RESPONSE TO COMMENTS  
AND FINAL PERMIT DECISION

OPDES Permit Number: OKS000101 City of Oklahoma City Municipal Separate Storm Sewer System (MS4) Permit

Date Prepared: December 29, 2023

Permit Action: Response to comments received on the proposed permit publicly noticed on October 20, 2023, by DEQ, and by the City of Oklahoma City on October 24, 2023; and final permit decision to reissue OPDES Permit No. OKS000201.

Item 1: Table I-1 Existing Approved TMDLs Affected by Permittee(s)’ Stormwater Discharges (page 12)

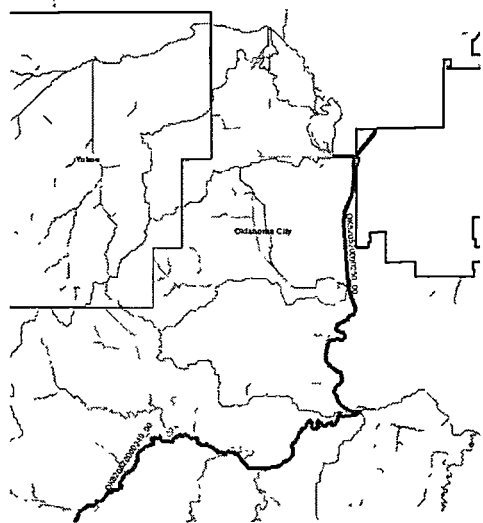
Item 1 Comment: Regarding water body identification (WBID) segment OK520520000250\_00, North Canadian River, highlighted in Table I-1 of the draft permit (see highlighted in table above). The stream segment has a load reduction identified for fecal coliform but not for Escherichia coli (*E. coli*) or enterococcus (see Table ES-3 of the Bacteria Total Maximum Daily Load (TMDL) for North Canadian River Area (OK520520)).

Fecal coliform standards are no longer part of the Primary Body Contact Recreation (PBCR) water quality standard(s) and beneficial use assessment protocol. The segment (as provided in the TMDL) also lacks additional *E. coli* and enterococcus data supporting a Total Maximum Daily Load (TMDL) assignment/reduction for those parameters.

Question 1: Without a supported water quality standard for fecal coliform and since a TMDL was not developed for *E. coli* or enterococci, is it appropriate to assign a bacteria reduction requirement based on a historical standard which is now obsolete?

Question 2: With regard to the North Canadian bacteria TMDL, is it appropriate to name all stream segments in OKC’s draft MS4 permit that were studied but not assigned a TMDL? Table ES3 (see below) of the TMDL provides percent reduction goals for the following WBIDs OK520510000110\_20, OK520520000010\_00, OK520520000010\_10, OK520520000010\_20, OK520520000010\_30, OK520520000010\_40, OK520520000210\_00, OK520520000250\_00, OK520520000070\_00, OK520520000150\_00, and OK520520000240\_00. OKC’s draft permit, Table I-1 lists Airport Heights Creek as an existing approved TMDL. The NCR bacteria TMDL provides: “Airport Heights Creek (OK520510000350\_00) is not impaired for bacteria. Therefore, a TMDL will not be developed for the creek. Instead, the TMDL for North Canadian River (OK520520000010\_40) watershed will include the Airport Heights Creek sub-watershed.”

With regard to Question 1 as to whether it is appropriate to assign a bacteria reduction requirement based on a historical water quality standard (WQS) for fecal coliform which is now obsolete (replaced by WQS for *E. coli* or enterococcus), DEQ has consulted with EPA. EPA has directed that these fecal coliform Total Maximum Daily Loads (TMDLs) and associated Wasteload Allocations (WLAs) and required percent reductions remain in effect and the required percent reductions should be applied to *E. coli* or enterococcus until such time as new TMDLs for *E. coli* and/or enterococcus are approved or established. The final permit has been revised to add a footnote to Table I-1 to clarify this requirement. DEQ notes that this requirement also applies to stream segment OK52052000070\_00 (Crutcho Creek), for which the TMDL also established required percent reductions for fecal coliform, but not for *E. coli* or enterococcus.

With regard to Question 2 as to whether it is appropriate to name all stream segments in OKC's draft MS4 permit that were studied but not assigned a TMDL, DEQ concurs that only those stream segments for which TMDLs and associated WLAs and required percent reductions should be included in the permit. Since Airport Heights Creek (OK520510000350\_00) was studied and determined to not be impaired for bacteria and thus to not require a TMDL to be developed, it was included in Table I-1 in error. The final permit has been revised to delete Airport Heights Creek (OK520510000350\_00) from Table I-1.
